CITY OF MANTECA

SUBJECT: TEMPORARY USE PERMIT 18-114: CHRISTMAS TREE LOT FOR SAVE MART # 12

Project Description: TUP for Christmas Tree Lot at Save Mart # 12

Exhibit "A"

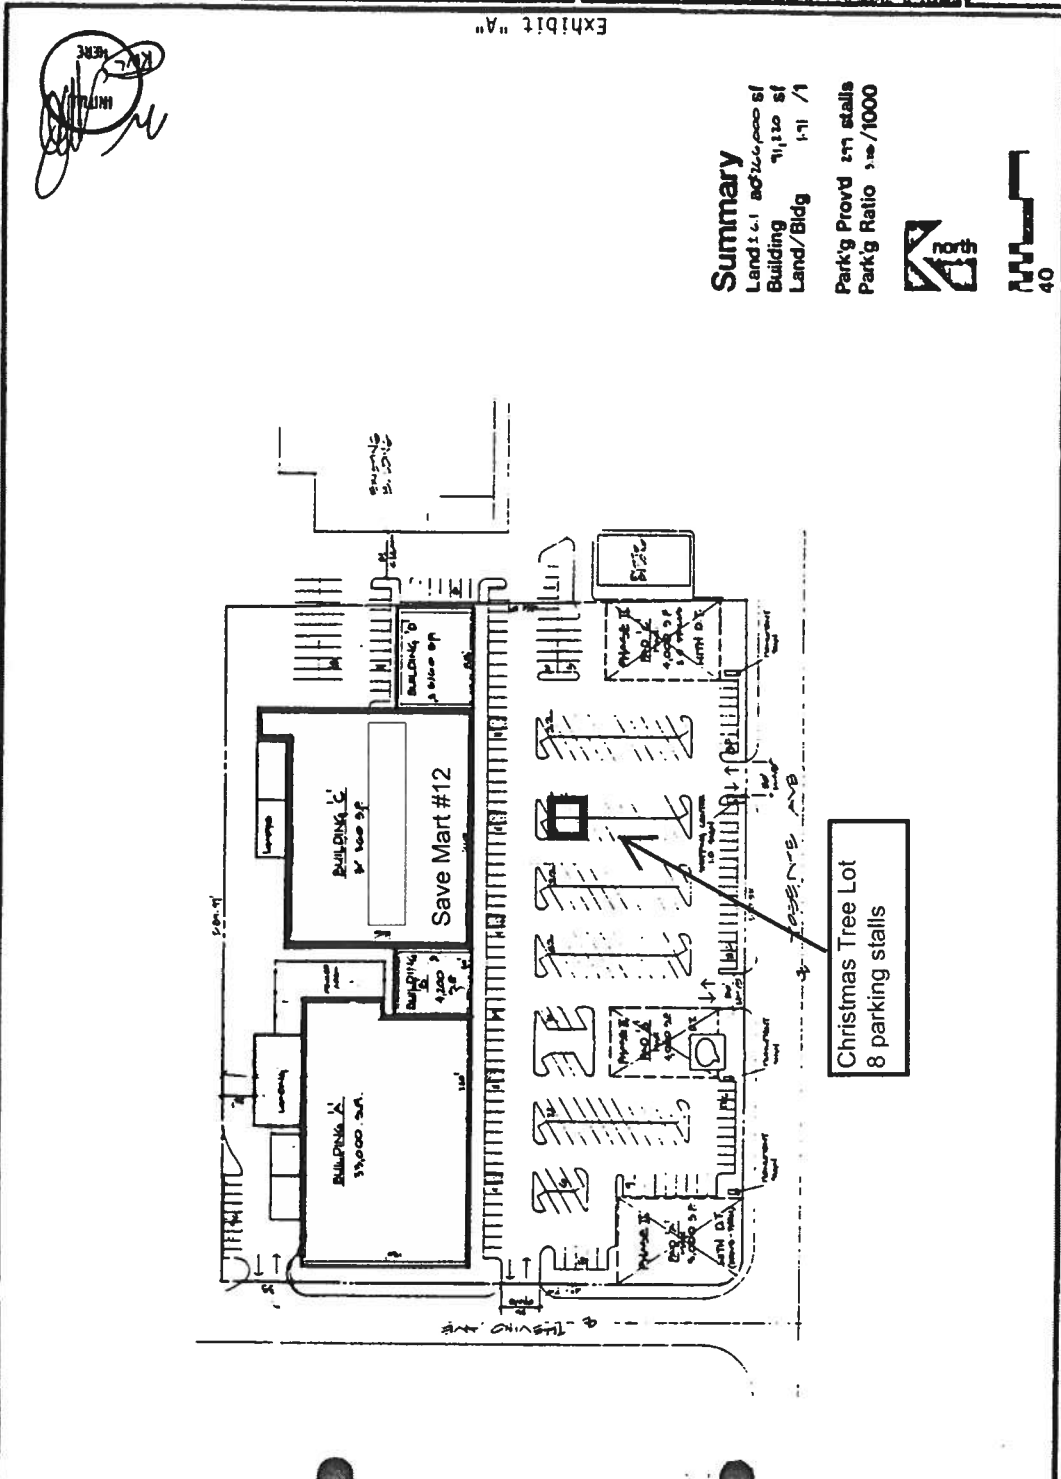
6. Provide an accessible route of travel from the Christmas lot area to the accessible parking space, accessible restroom facilities and to the public road/sidewalk. Clearly show accessible path of travel on the site plan.
7. Electrical permit is required for any electrical work. Disregard if not applicable.

1. Provide an accessible route of travel from the Christmas lot area to the accessible parking space, accessible restroom facilities and to the public road/sidewalk. Clearly show accessible path of travel on the site plan.
2. Electrical permit is required for any electrical work, disregard if not applicable.
